Interactive comment on “Aircraft vertical profiles during summertime regional and Saharan dust scenarios over the north-western Mediterranean Basin: aerosol optical and physical properties” by Jesús Yus-Díez et al.

Answer to anonymous Referee #2 by the authors.

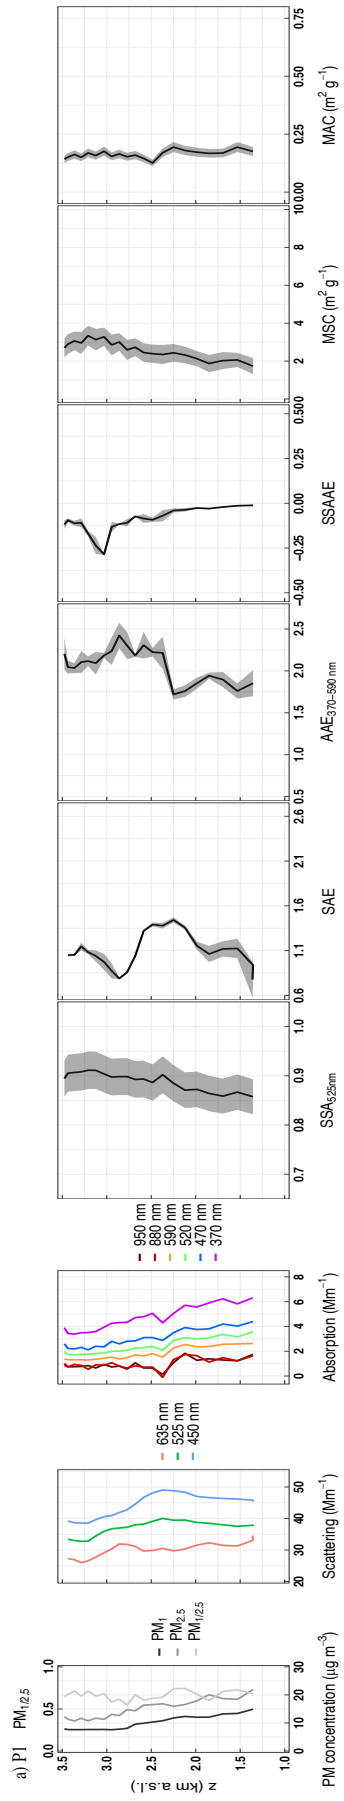
-My main qualm with the paper is that Figure 7 and 8 are quite difficult to read. It is as if the ratio of the figures is off; they should be slightly wider. I realize the challenges associated with presenting this much information at once- and I see the logic behind how these figures are organized. If the individual plots can be widened slightly or maybe if the legends could be moved to inside the plots to allow them to get bigger, that might help the reader. But the paper could be published with the figures as is if necessary.

We have taken into account the suggestion and modified the figures so that these are now a bit wider. Below an example of the new format for P1. Also, we would like to point out that in the conversion from the discussion manuscript to a 2-column text, there will be more space to increase the size of the figure.
